## Charlotte Historic District Commission Application for a Certificate of Appropriateness

February 11, 2009

ADDRESS OF PROPERTY	724 Walnut Avenue, Wesley Heights Local Historic District
SUMMARY OF REQUEST	Addition & Tree Removal
OWNER	Brian Gay
APPLICANT	Brian Gay

FRONT

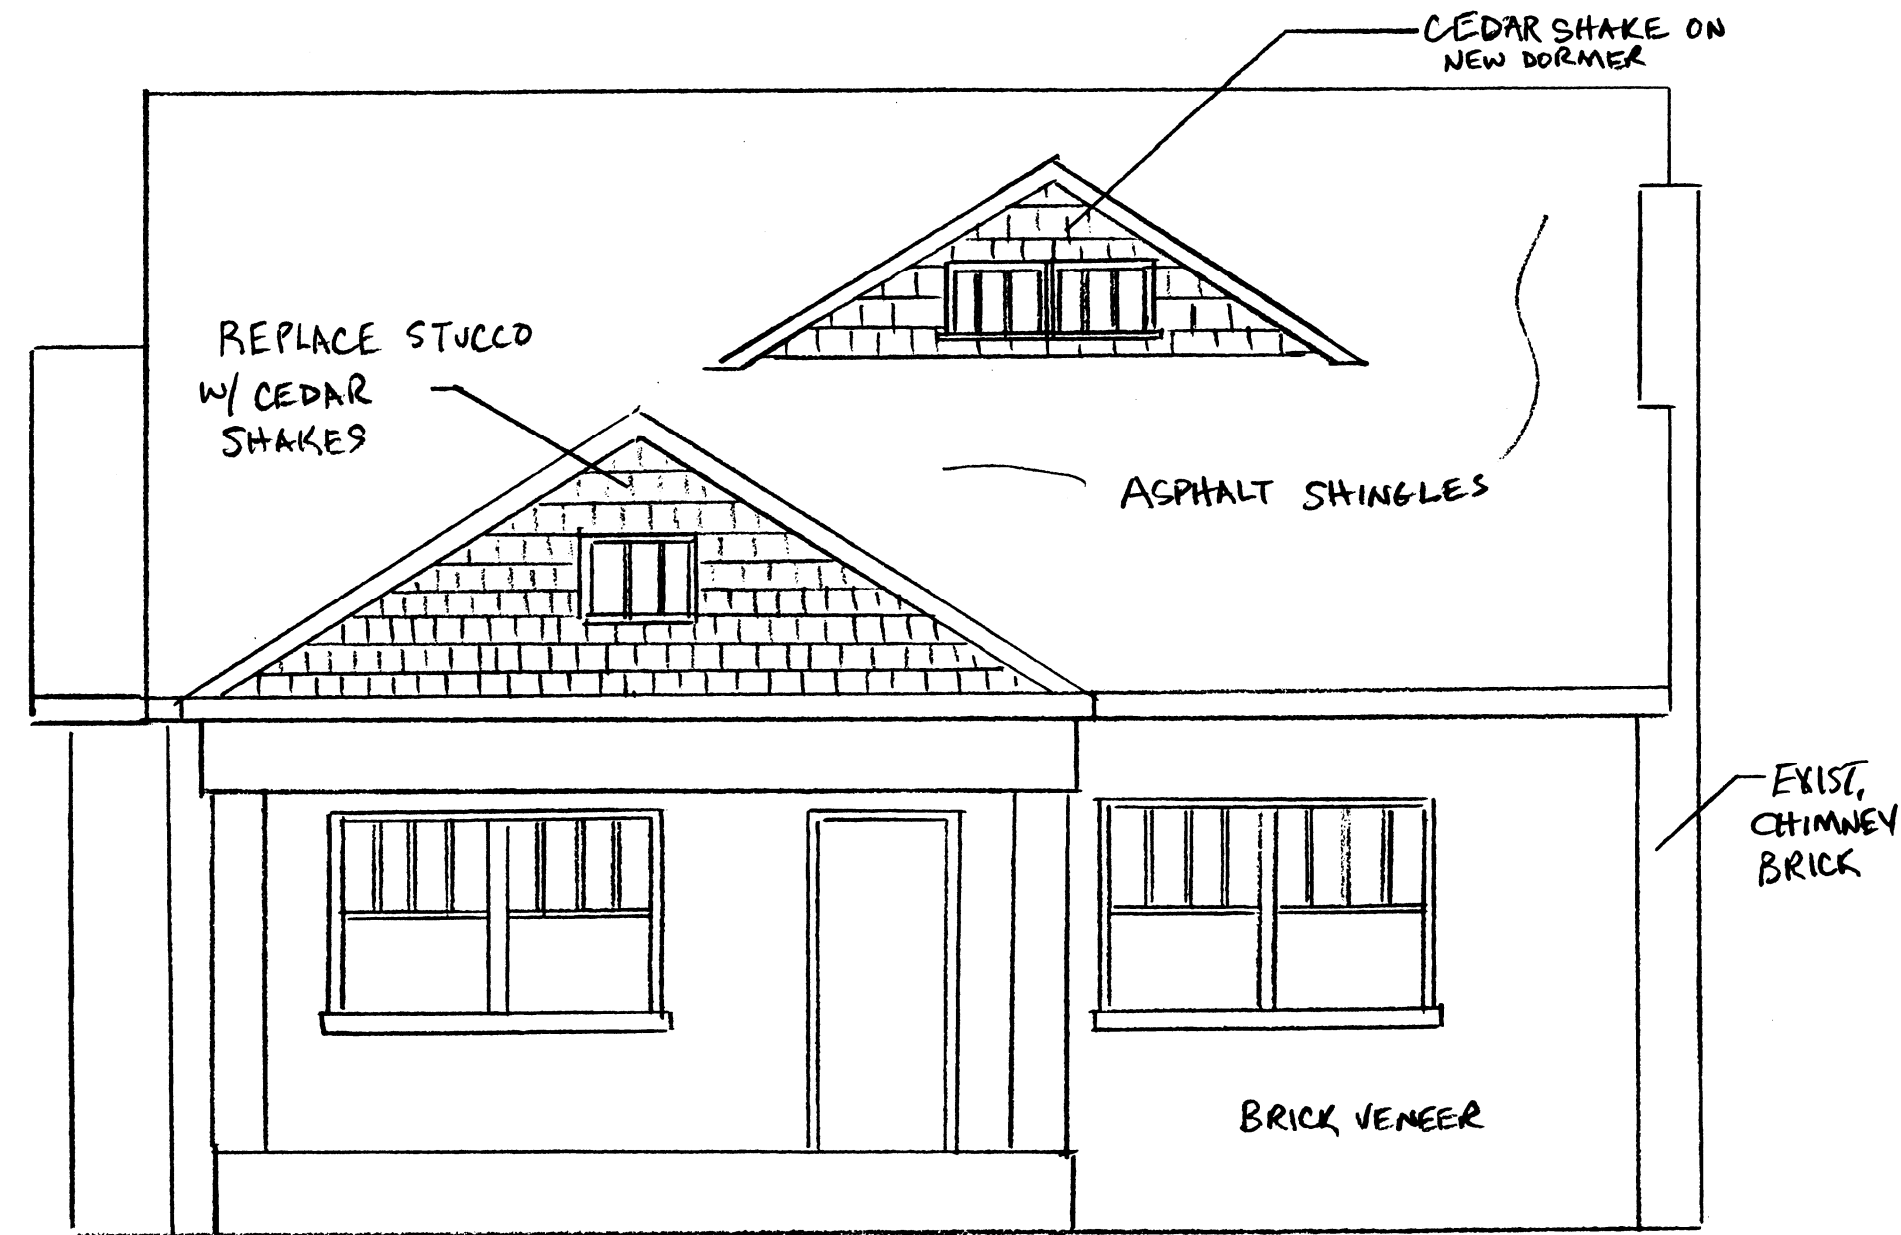
The attached plans are revised based on the comments of the HDC in January. The revised plans address the first three points. The inaccuracies in the façade elevation that were noted at the January HDC meeting have been corrected. The applicant has chosen to replace the original stucco material in the existing gables with wood shakes, and that same material will be used in the new gables shown on the plans. The originals of the plans submitted to staff are drawn at a ¼ scale, and all dimensions can be determined from those drawings.

724 WALNUT AVE.	
SCALE: 1/4" = 1'	APPROVED BY:
DATE: 12/12/08	DRAWN BY:
ELEVATION - PROPOSED - SIDES	
DRAWING

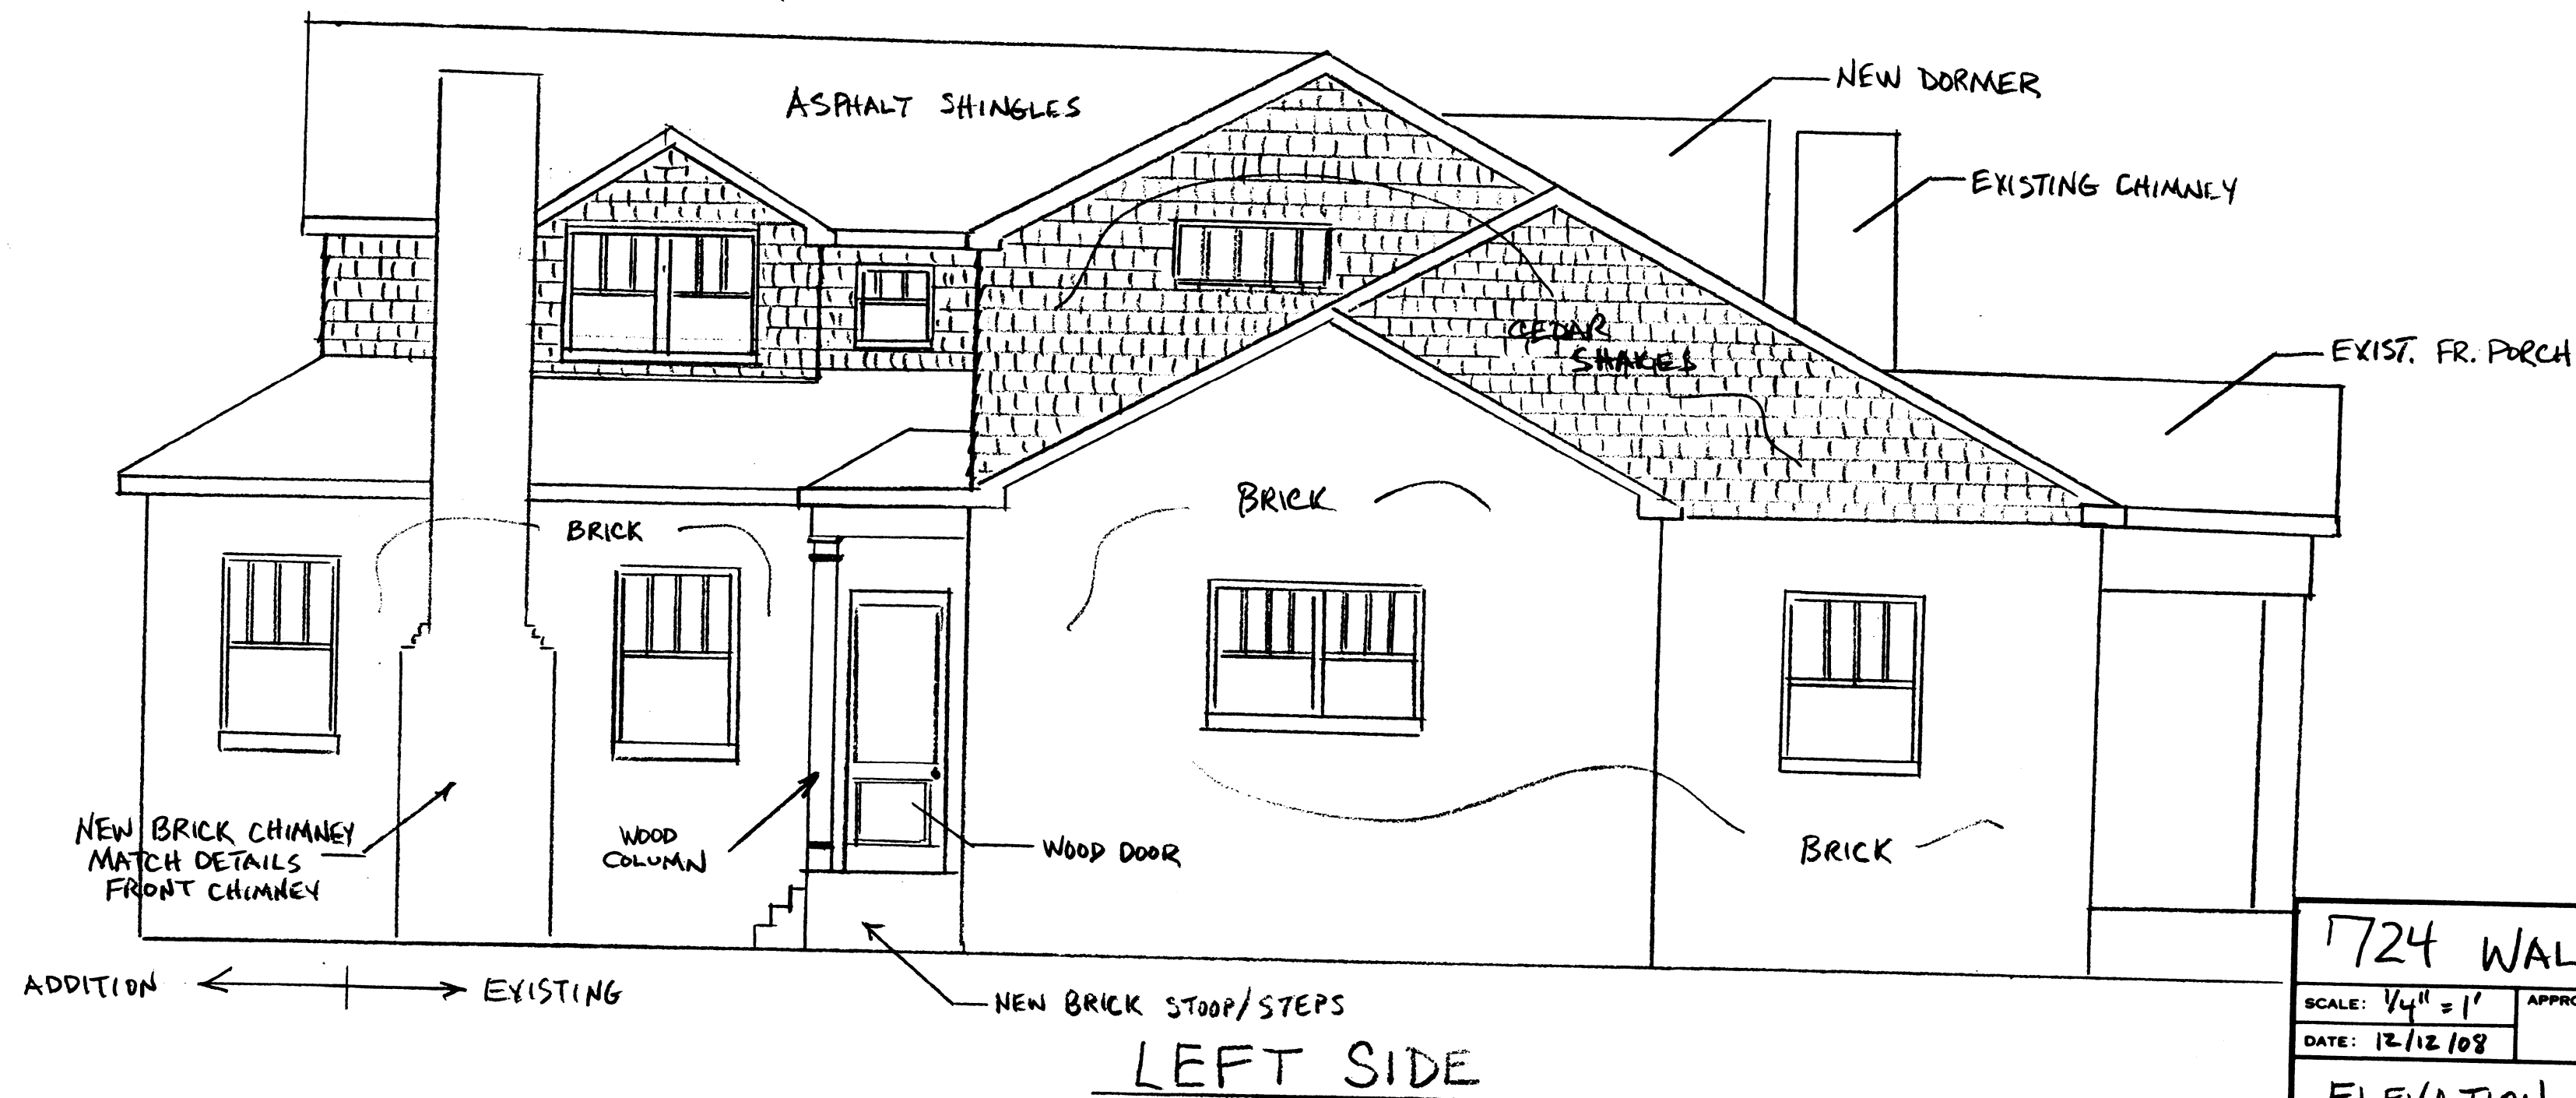
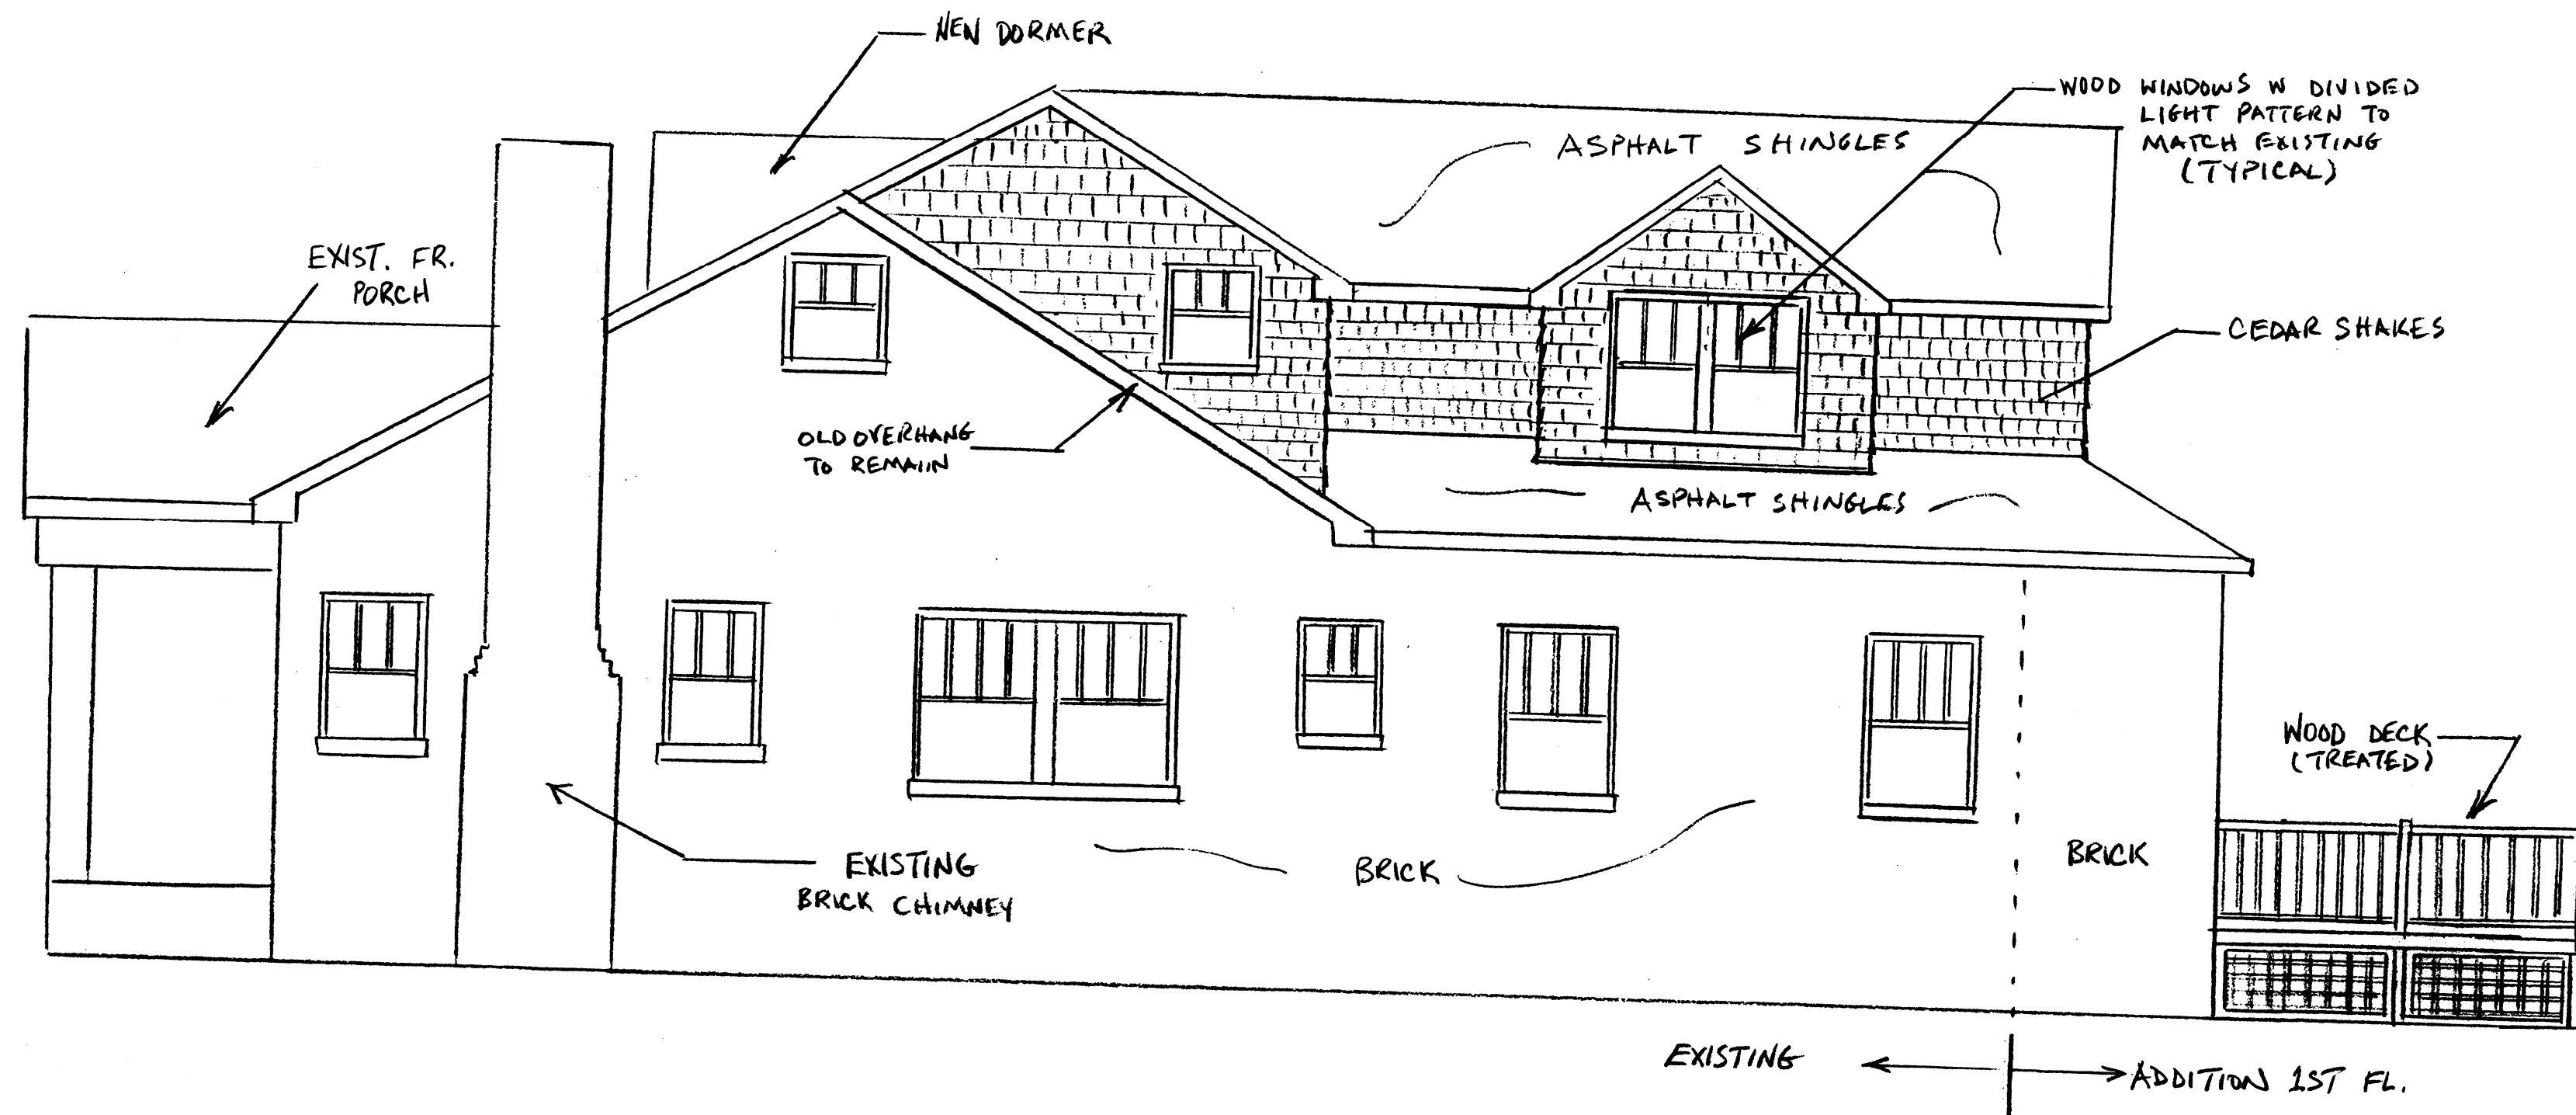
The revised drawings also show a redesign of the side elevations that incorporate a design suggestion made at the January HDC meeting, simplifying the overall side elevations by incorporating new second floor windows into a dormer and straightening out the new walls of the new second floor rear facing gable.
